**DA 374-11-00 MOD 7: Various Lots; Wilmatha Road, Fifield; Sunrise Mine  
Response to Submissions**

## TAB A – Recommended Conditions on Modification No. 7

**Figure 1 - Approved and Modified Rail Siding Location**

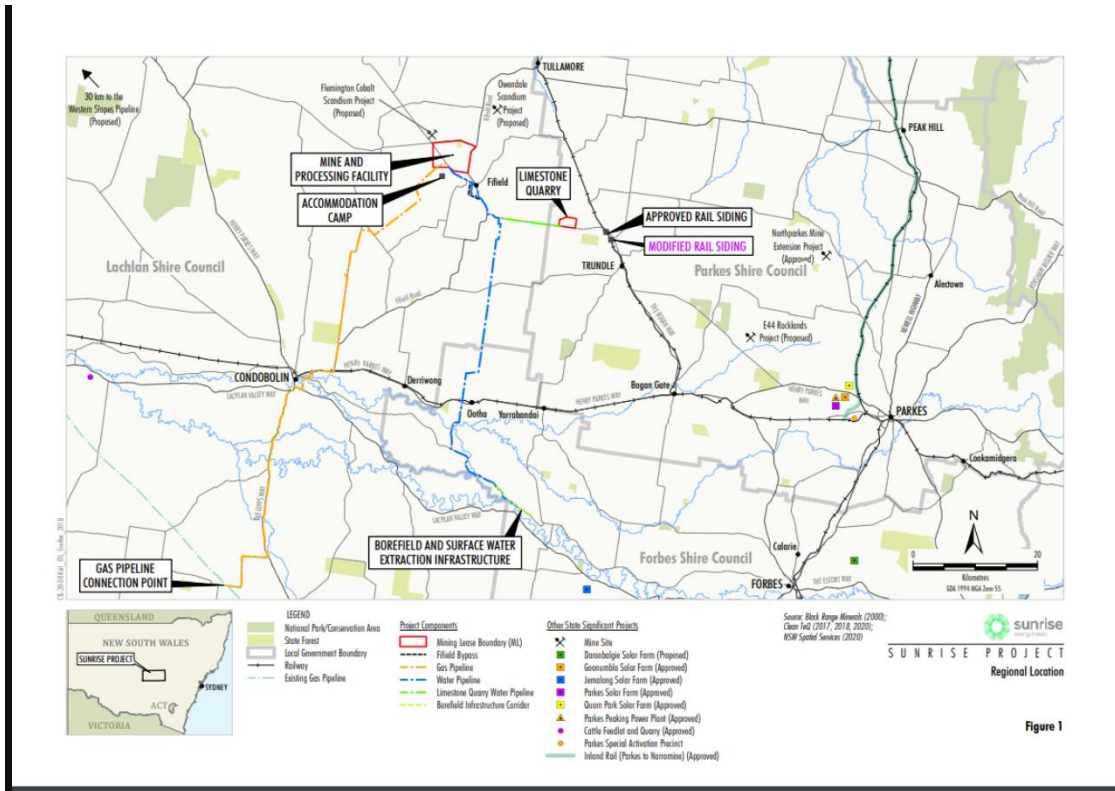
- a. In the event that a safety assessment on the public level crossing at Scotson Lane (circled in purple in **Figure 1**) finds that the crossing needs to be upgraded, the applicant must upgrade at its costs subject to approval from TfNSW.
- b. The relevant council will be requested to update the current Road Rail Interface Agreement to reflect the change to the level crossing in accordance with the Rail Safety National Law 2012.

The applicant responses in Submission Reports that any requirement to upgrade the Scotson Lane level crossing should be determined based upon the outcomes of the rail level crossing safety assessments as part of its efforts to satisfy conditions 43 and 44, Schedule 3 of Development consent (DA 374-11-00). As such, it is important that the level crossing is upgraded if the safety assessment finds in support of such upgrade in order to accommodate the rail siding regardless of an unlikely significant increase in the total number of vehicles using the level crossing.
